PRE-BID CLARIFICATIONS NO. 1 DATED 13.08.2025 TO PRE-BID QUERIES ON STIPULATIONS OF BID DOCUMENT AGAINST NIB NO. 483 DATED 27-05-2025 FOR "PACKAGE-III: CIVIL WORKS OF POWER INTAKE, HEAD RACE TUNNEL, SURGE SHAFT, VALVE CHAMBER, PRESSURE SHAFTS & PENSTOCK, UNDERGROUND POWERHOUSE COMPLEX (COMPRISING OF POWERHOUSE CAVERN, TRANSFORMER - GIS CAVERN, COLLECTION CHAMBER, MAIN ACCESS TUNNEL (MAT), CABLE ACCESS TUNNEL (CAT)) UNIT TAIL RACE TUNNELS, MAIN TAIL RACE TUNNEL, POTHEAD YARD AND VARIOUS CONSTRUCTION ADITS PERTAINING TO TATO-II HYDRO ELECTRIC PROJECT (700 MW), ARUNACHAL PRADESH"

(THIS PRE-BID CLARIFICATIONS SHALL SUPERSEDE THE CORRESPONDING STIPULATIONS OF THE BID DOCUMENT, WHEREVER THESE ARE AT VARIANCE.)

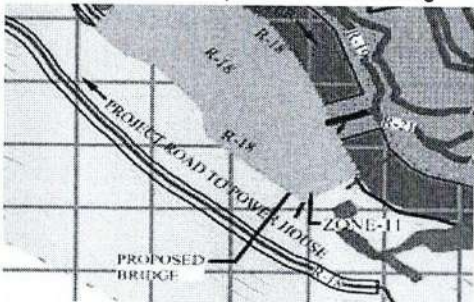
28	Part-8 Bill of Quantities Prestressed cable anchor	BOQ No. 4.35 Prestressed Cable Anchor	Kindly provide the specific locations where the Pre-stressed Cable Anchors, as mentioned in the BOQ, are proposed to be used.	Same shall be decided based on encountered geology during construction stage design.

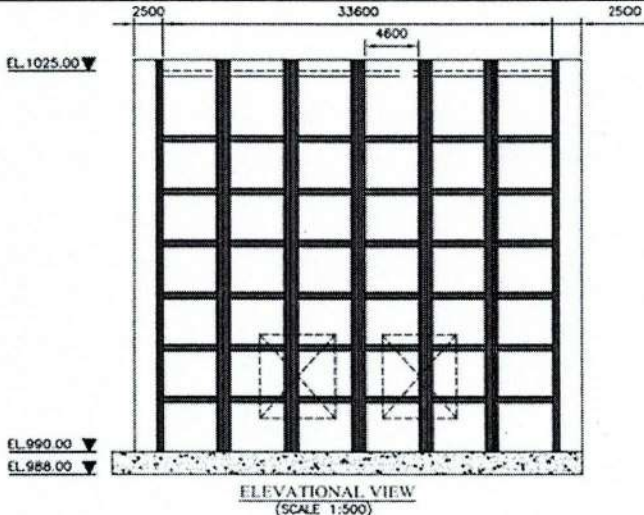
Sl. No.	Reference to Bid Document Clause	Provision of Bid document	Pre-Bid queries of Bidders	NEEPCO's Clarifications
			<p>a total length of 10.472 km, including audit lengths, execution periods, and the respective excavation method (drill & blast/machine). (Photo attached for reference)</p> <p>Such structured information greatly supports the bidder in planning, accurate cost estimation, and fair competition. Hence, the bidder kindly requests the Authority to provide a similar comprehensive construction methodology and component-wise technical details for this project."</p>

Sl. No.	Reference to Bid Document Clause	Provision of Bid document	Pre-Bid queries of Bidders	NEEPCO's Clarifications
215	Drawing: Intake plan and section		<p>As per Bid Document Part-2, in the drawing for the Intake Plan and Section, the elevation drawing is provided. The bidder requests clarification on the type of mesh indicated—whether it is steel, concrete, or any other material.</p> <p>The bidder kindly requests that the material specification be clearly stated.</p>	<p>The instant item is Trash Rack and the material of mesh is Reinforced Concrete on which Hydro mechanical component shall be supplied and erected by HM contractor.</p>

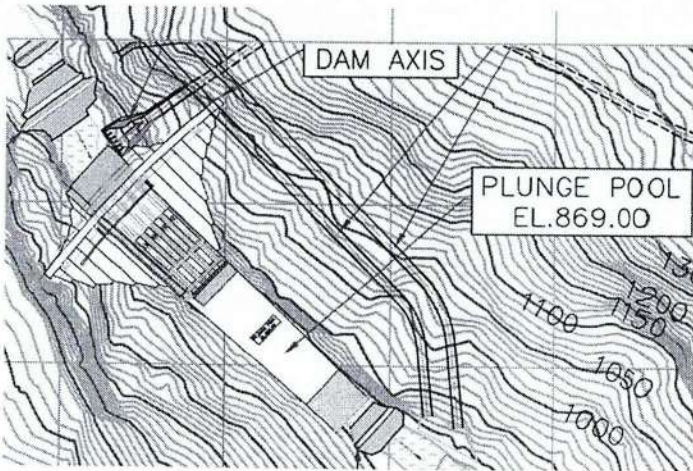
Sl. No.	Reference to Bid Document Clause	Provision of Bid document	Pre-Bid queries of Bidders	NEEPCO's Clarifications
216	Drawing: Intake section (Sheet 1 of 1)		<p>As per Bid Document Part-2, in the drawing titled "Intake Section (Sheet 1 of 1)", Section A-A has been provided.</p> <p>The bidder respectfully requests the following clarifications:</p> <p>Type of Slope Protection and Side Slope:</p> <p>Kindly specify the type of slope protection and the side slope proposed in this section.</p> <p>Material Specifications:</p> <p>Please provide the detailed material specifications to be adopted for slope protection.</p> <p>Construction Methodology:</p> <p>Request to share the construction methodology to be followed for the slope protection work in this section.</p> <p>This information is essential for understanding the scope and for accurate estimation during bidding.</p>	<p>The tender drawings may be read in conjunction with the Bill of Quantity, GTS and PTS. Preliminary details are already enclosed in the bid document. Any further details shall be firmed up during detailed design stage</p>
